## ***Interactive comment on “Sensitivity study on the main tidal constituents of the Gulf of Tonkin by using the frequency-domain tidal solver in T-UGOm” by Violaine Piton et al.***

**Violaine Piton et al.**

Anonymous Referee#1 Received and published: 30 August 2019.

Fig. 1.

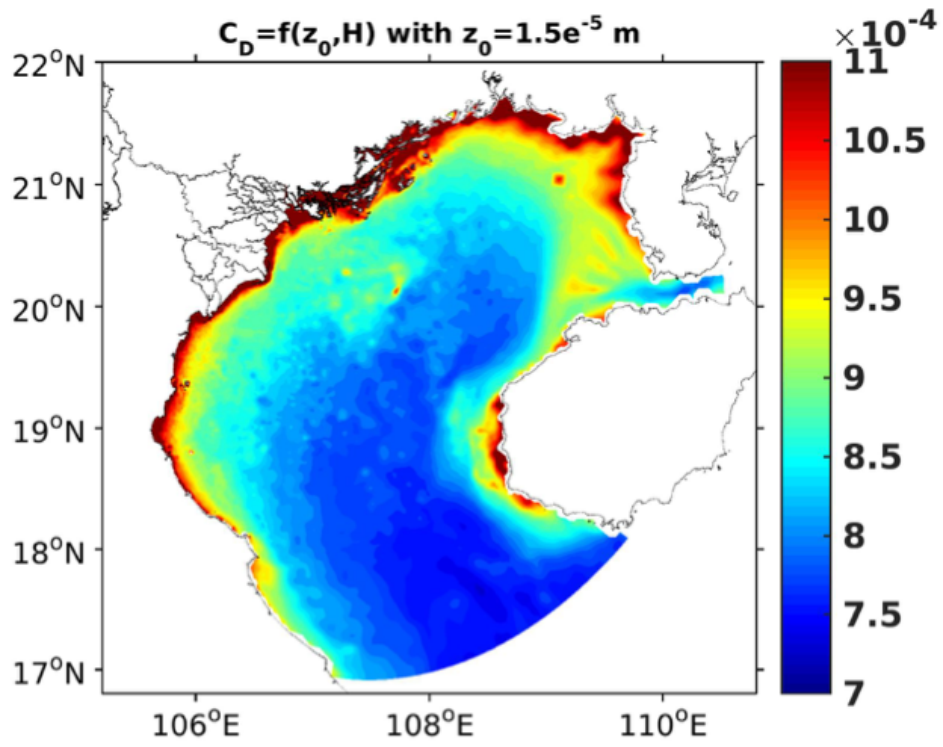
#29 - B - Optimization conducts to  $C_d=0.9 \cdot 10^{-3}$  m, and  $z_0=1.5 \cdot 10^{-5}$  m. A map of  $C_d$  for  $z_0=1.5 \cdot 10^{-5}$  m would help to see the differences in term of  $C_d$  between the two parameterizations.

We thank the reviewer for his/her suggestion, and plotted a map of  $C_D=f(z_0,H)$  with  $z_0=1.5 \cdot 10^{-5}$  m (Fig. 1). This figure allows to spot the differences between the different parameterizations: a constant  $C_D=0.9 \cdot 10^{-3}$  m or  $C_D=f(z_0,H)$ . Values of  $C_D$  range from 0.8 to  $1.1 \cdot 10^{-3}$  m with lower values in the deepest part of the basin and higher values along the coasts. As  $C_D$  spatial variability is therefore rather weak, it also explains why both parameterizations ( $C_D$  constant or  $C_D$  varying with  $z_0$ ) produce similar results.

→ Following this comment and since the spatial variability of  $C_D$  is very weak, we did not include the map for the sake of conciseness, but acknowledged this point about the

Figure 1: Map of  $CD=f(z_0,H)$  (in m) with  $z_0=1.5 \times 10^{-5}$  m.

Fig. 2.

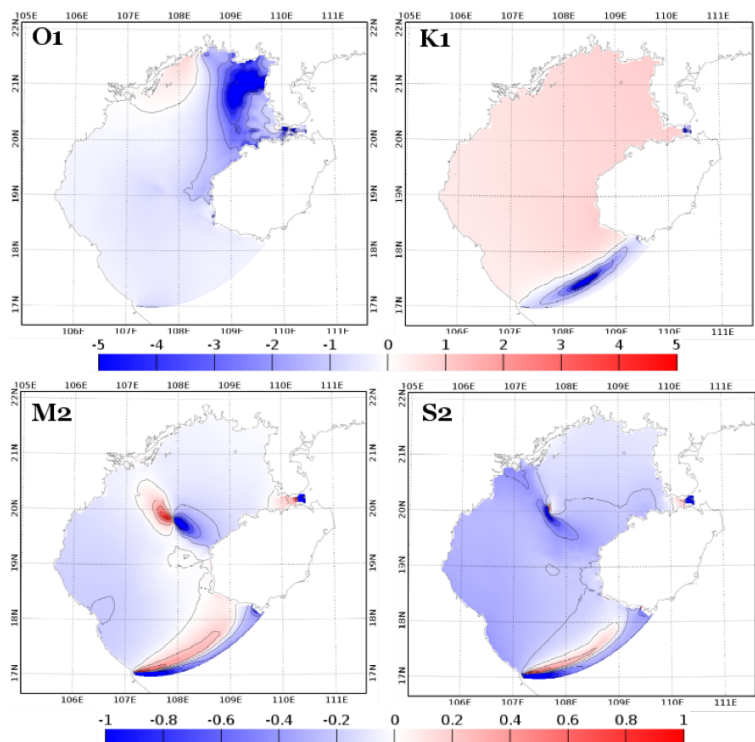
#29-C- The cumulative errors between  $CD=cst$  or varying with  $z_0$  are very similar (11.5 and 10.96 cm). Is there a significant improvement with  $CD=f(z_0,H)$ ? It is not justified why the authors choosed  $CD=f(z_0)$  rather than  $CD=cst$  for the following. Indeed, SET4, could have been made with  $CD$  varying spatially, instead of  $z_0$  varying spatially.

We agree with the reviewer that a decrease of the cumulative errors of 0.54 cm between simulations with  $CD=cst$  and simulations with  $CD=f(z_0,H)$  is small. To examine into details the question of significance of this result, we plotted the maps of relative differences (in both amplitude and phase) for all four waves between the two simulations ( $CD=0.9 \times 10^{-3}$  m and  $CD=f(z_0=1.5 \times 10^{-5}, H)$ ) taking FES2014b-with-assimilation as a reference (Fig. 2 below) i.e:

The results are heterogeneous and vary from a wave to another. For K1, the positive values almost all over the basin indicate that the simulation with a constant CD has the smallest difference to the reference FES2014b. However, the solution is improved only by  $\sim 1\%$  compared to simulation with  $CD=f(z_0)$  (Fig.2). Difference values for O1, M2 and S2 are mostly negative. This means that simulation with  $CD=f(z_0)$  slightly improves (from 0.5% to 5%) the solution compared to simulation with a constant CD.

These results show that differences between both simulations relatively small and not significant (smaller than 5%), neither in average nor locally : they thus finally suggest that the sensitivity of the tidal solutions over the GoT to the choice of bottom friction parameterization (constant CD vs. spatially varying with  $CD=f(z_0)$ ) is limited compared

Figure 2: Relative differences (in %) between simulation with  $CD=f(z_0=1.5 \times 10^{-5}, H)$  and simulation with  $CD=0.9 \times 10^{-3}$  m compared to FES2014b-with-assimilation for the tidal harmonics of O1, K1, M2 and S2.

Fig. 3.

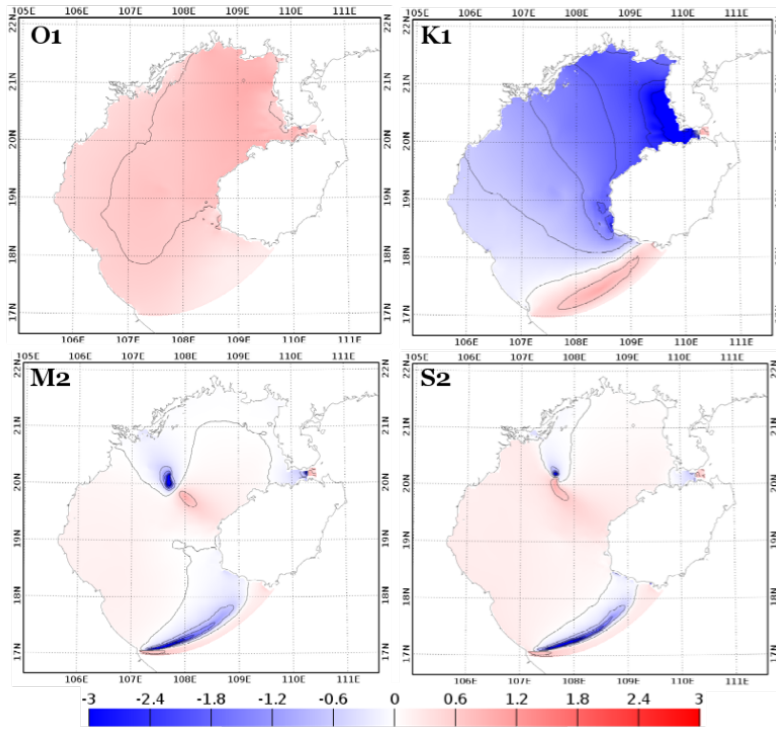
#30-C. SET4: the three areas are finally only two areas (Regions 1 and 2 with the same  $z_0$ ), and the  $z_0$  in areas 1 and 2 is the one corresponding to SET2 optimized ( $z_0=1.5 \cdot 10^{-5} m$ ). Finally, SET4 is not so different from SET2, with very similar cumulative error (10.43 cm instead of 10.96 cm). Is the improvement significative?

#38-line 791: ‘the regionalisation of the roughness length into three regions, for addressing the issue of representing the complexity of seabed composition and morphology, moderately improved the accuracy of our simulation, with a lowest cumulative error for all four waves of 10.43 cm’, instead of 10.96 cm. We totally agree with this conclusion, is the improvement significative enough?

We agree with the reviewer that simulation named TEST 6 (from SET4) is finally similar to the simulation using  $CD=f(z_0=1.5e-5, H)$  (from SET2) and that therefore, TEST6 and  $CD=f(z_0=1.5e-5, H)$  show similar cumulative errors. To assess the significance of this result, we plotted the relative difference of the tidal harmonics for the four waves between simulation TEST6 and simulation using  $CD=f(z_0=1.5e-5, H)$ , taking FES2014b-with-assimilation as a reference(Fig. 3) i.e.:

Similar to the previous results presented in General comment #3 part 1, relative differences between the simulations are relatively small, heterogeneous over the GoT basin and varying from a wave to another. For O1, the positive values all over the GoT indicate that simulation with  $CD=f(z_0)$  (SET2) produces smaller differences to the reference (Fig. 3). This improvement compared to simulation “ TEST6” is however of only ~2%. On the opposite for K1, simulation “ TEST6” (SET3) produces smaller differences to the reference mostly all over the basin. The improvement is however smaller than ~3%. Regarding the semi-diurnal waves, simulation “ TEST6” shows smaller differences to the reference along the northern coasts of the GoT and along a branch near the southern open boundary of the domain, while simulation with  $CD=f(z_0)$  shows the smallest difference in the rest of the basin. Once again, the improvements from a simulation to another are relatively small (~1%).

Figure 3: Relative differences (in %) between simulation with  $CD=f(z_0=1.5e-5, H)$  and simulation from TEST 6 compared to FES2014b-with-assimilation for the tidal harmonics of O1, K1, M2 and S2.

Fig. 4.

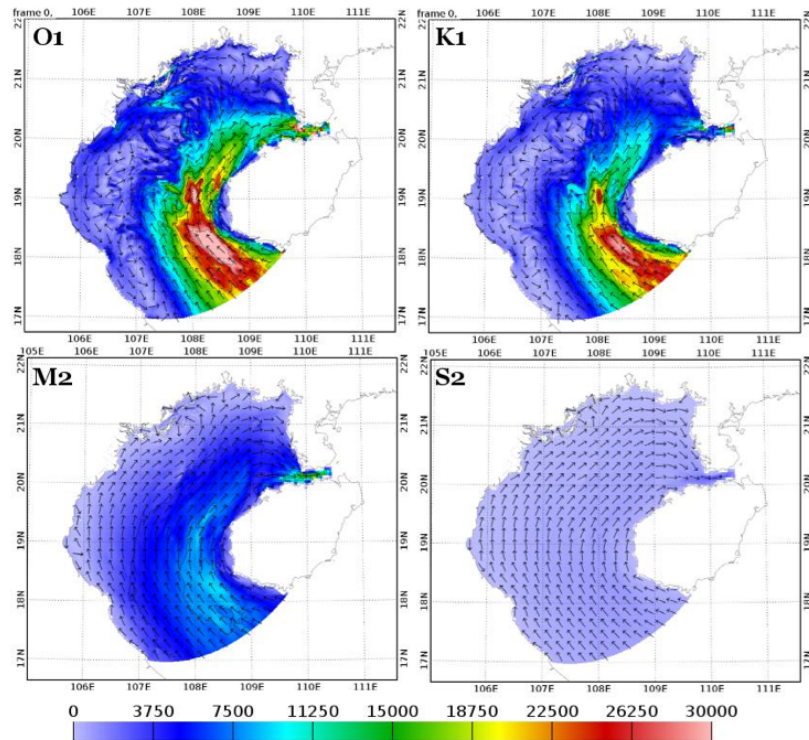
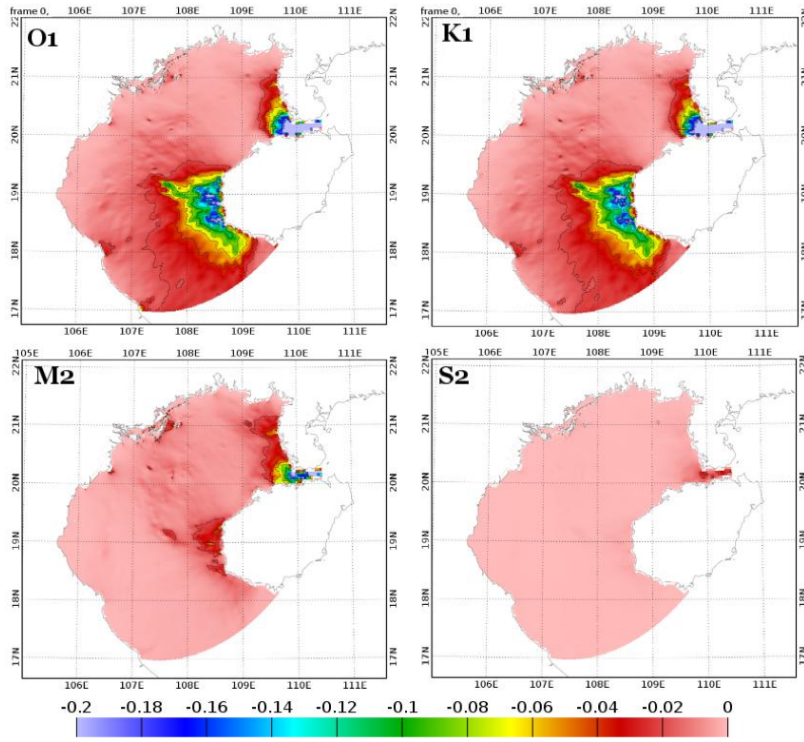
Part 3-The last point is that choosing for the mud area a linear expression instead of a quadratic one has no significative influence (SET3).

#30-B. SET3 has been conducted with a constant value of  $r$  and varying value of  $z_0$ . Without surprise, optimization leads to  $z_0=1.5 \cdot 10^{-5} \text{ m}$ , which is the optimized value of

The reference is 'Le Bars et al. 2010'. We understand the reviewer's concern on this particular point. Our hypothesis is that there is no improvement in simulations from SET3 (linear velocity profile in the area of fine mud) because the model sensitivity to the bottom friction is limited in the area since tidal energy fluxes and dissipation are themselves limited in this particular area. To confirm this hypothesis, we plotted maps of tidal energy fluxes (Fig. 4) and maps of bottom dissipation (Fig. 5) for all four waves. It appears that a branch of intense tidal energy fluxes enters the GoT from the south-eastern boundary (south of Hainan island) for O1, K1 and M2 (Fig. 4), and is dissipated along the western coasts of the island (Fig. 5). Energy fluxes also pick up in the Hainan Strait due to combined entering and exiting fluxes and are dissipated along this same strait. However, along the Red River Delta, both tidal energy fluxes and bottom dissipation are extremely limited for all four tidal constituents. Therefore, changes of dissipation mode along the Red River Delta, i.e. in the area of fine mud of SET3, do not significantly affect the tidal solutions as tidal energy flux and bottom dissipation are very weak. → Following this comment, Le Bars et al. 2010 has been added line 353-354, explanations on why simulations from SET3 were not improved with the use of a linear velocity profile in the area of fine mud are now added lines 657-666 and Fig. 5 (as Fig. 14 in the manuscript) is added to the revised manuscript,

Figure 4: Tidal energy flux ( $W m^{-1}$ ) for O1, K1, M2 and S2 computed from model outputs of simulation 'TEST 6'.

Figure 5: Bottom dissipation flux ( $W m^{-2}$ ) for O1, K1, M2 and S2 computed from model outputs of simulation "TEST 6".

Fig. 6.

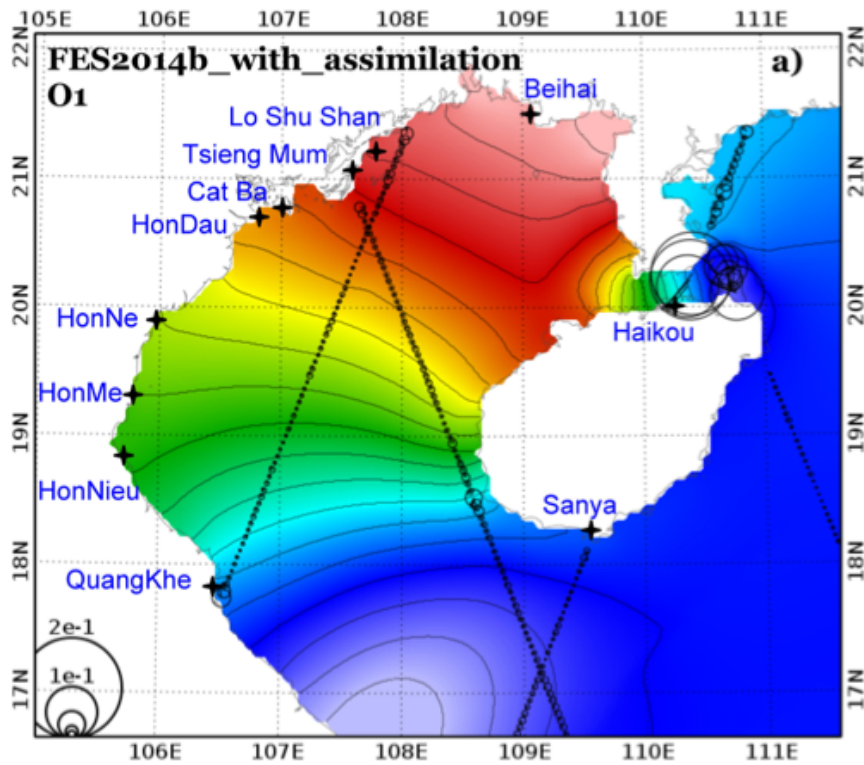
Part 3- Another point is that comparisons were made only between the model and altimetry, and comparison with tide gauges would be of great interest for the paper. For example, on Figure 6 authors could add dots at tide gauges locations colored with corresponding M2 amplitude.

We agree with the reviewer's suggestion that comparisons of simulated tidal solutions with tide gauges is of great interest for this study. Therefore, we compared the tidal harmonics of TKN, TKN-gebco, FES2014b-without-assimilation and FES2014b-with-assimilation with tidal harmonics from 11 gauge stations along the Gulf coast (provided by the International Hydrographic Organization, IHO). The positions of these stations are now shown in Fig. 5 a of the manuscript (and on Fig. 6 of the present text).

Figure 6: O1 tidal amplitude (in m) from FES2014b-with-assimilation superimposed

Fig. 7.

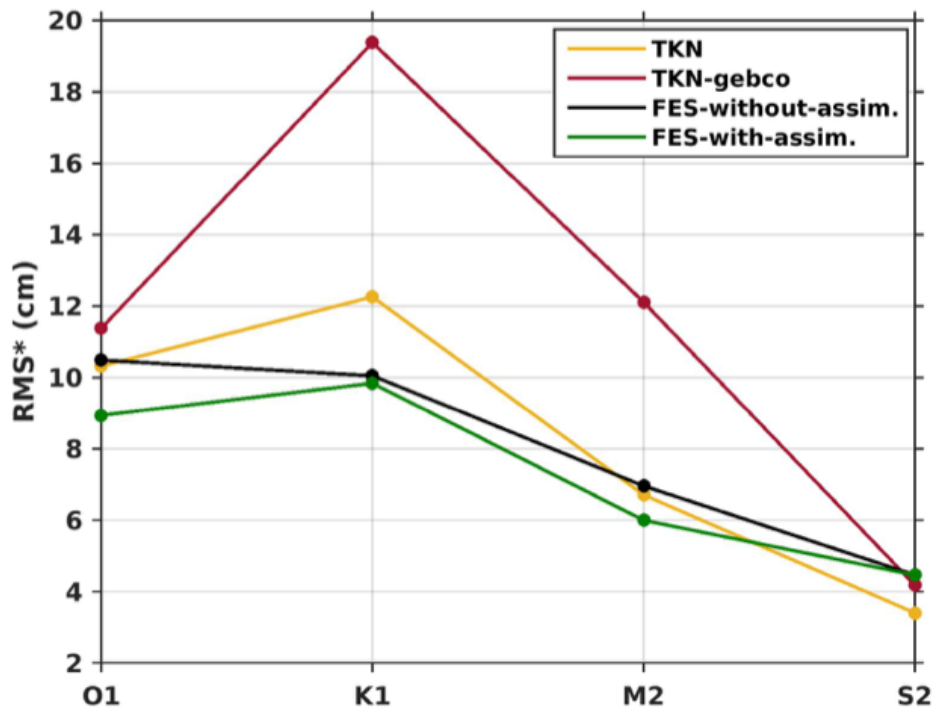
#41- line 806: 'Our resulting configuration brought a clear improvement in the tidal solution compared to previous 3D simulations from the literature and to the tidal atlas FES2014b (without data assimilation) for the semi-diurnal waves.' The improvement compared to FES2014b is not so clear if we look at Figure 6 for example. The addition of tide gauges data should greatly help to qualify the results.

RMS\* errors between modelled and observed tidal harmonics from tide gauges are now shown in Fig. 16 b of the manuscript (and on Fig. 7 of this document). First, compared to TKN-gebco, TKN gives smaller errors for all four waves considered: RMS\* for K1 are reduced by ~40% in TKN compared to TKN-gebco and RMS\* for M2 are reduced by ~45% in TKN compared to TKN-gebco. This result again confirms that TKN configuration improves the tidal representation over the GoT. Second, TKN simulation shows also smaller RMS\* errors than FES2014b-without-assimilation simulation for O1, M2 and S2. In addition, TKN even minimizes S2 RMS\* errors compared to FES2014b-with-assimilation. Our improved configuration however fails to improve the solution of K1, compared to the two FES2014b products. This last result is due to the fact that the unstructured grid used in FES2014b-(with and without-assimilation) is better adapted for the representation of the complex coastal topography than the structured grid that will finally be used in our tridimensional model and that is therefore used in TKN configuration. →These tide gauges data are presented in the revised manuscript lines 537-542, and the comparison of our simulations with those tide gauges data is now discussed in section 3.2.1 (average assessment over the domain) in the manuscript, lines 737-743.

Figure 7: RMS\* errors between numerical simulations (TKN, TKN-gebco, FES2014b-without-assimilation, FES2014b-with-assimilation) and tide gauges harmonics for O1, K1, M2 and S2.

Fig. 8.

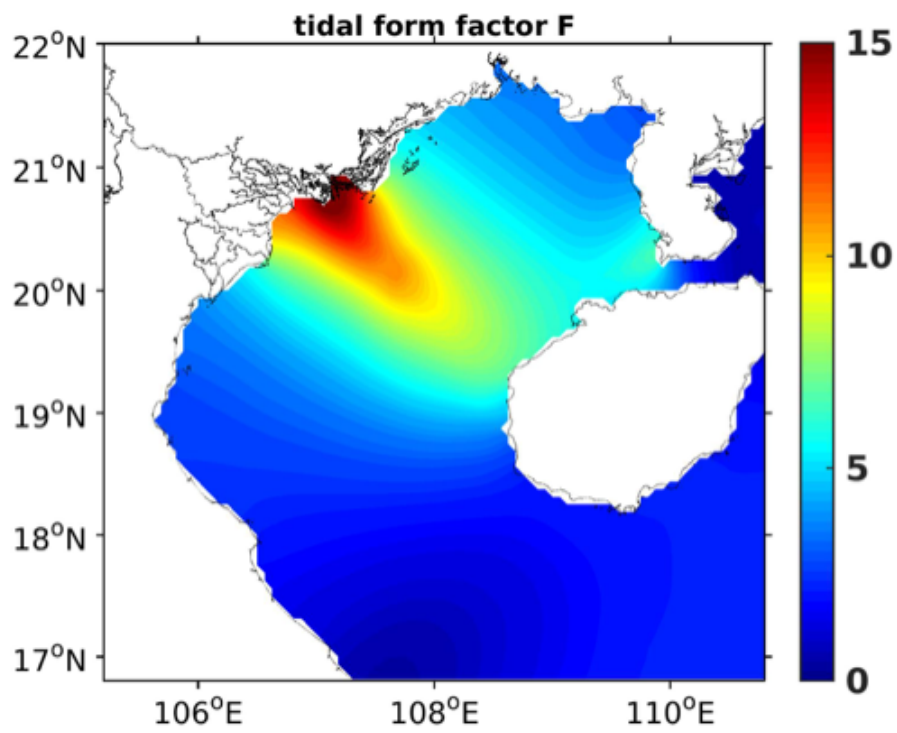
4- line 153-162: maybe a map of F would be useful, as the variation of F is here described spatially.

As suggested by the reviewer, we plotted a map of F where we clearly see that the tidal regime over the GoT is mainly diurnal ( $F>3$ ), except in the southwesternmost part of the GoT where the regime is mixed dominantly diurnal ( $1.5<F<3$ ) (Fig. 8). → this map is now included in our manuscript (as Fig. 2), line 163.

Figure 8: Map of tidal form factor F computed with the amplitudes of tidal waves obtained from FES2014b.
